## SERVICE BULLETIN

**APPLICABILITY:** 2019 MY Outback & Legacy / Key Start Ignition      **NUMBER:** 15-299-22R  
**SUBJECT:** Remote Engine Starter (RES) /      **DATE:** 08/02/22  
Intermittent Horn Beeping Discontinued      **REVISED:** 11/22/24  
Part Number H001SAL003

**PART INFORMATION:**

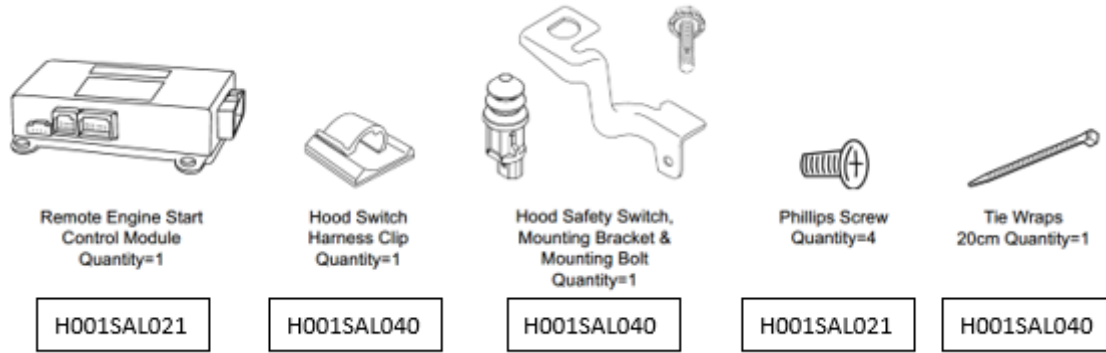
The RES installation kit applicability for MY19 has been changed from H001SAL003 to H001SAL002 (also applicable to MY18).

BOTH part numbers H001SAL021 (RES Control Module) and H001SAL040 (Hood Switch & Bracket) are required. The components included are shown below.

Part Description	Part Number
REMOTE ENGINE START ECU	H001SAL021
HOOD SWITCH / BRACKET	H001SAL040
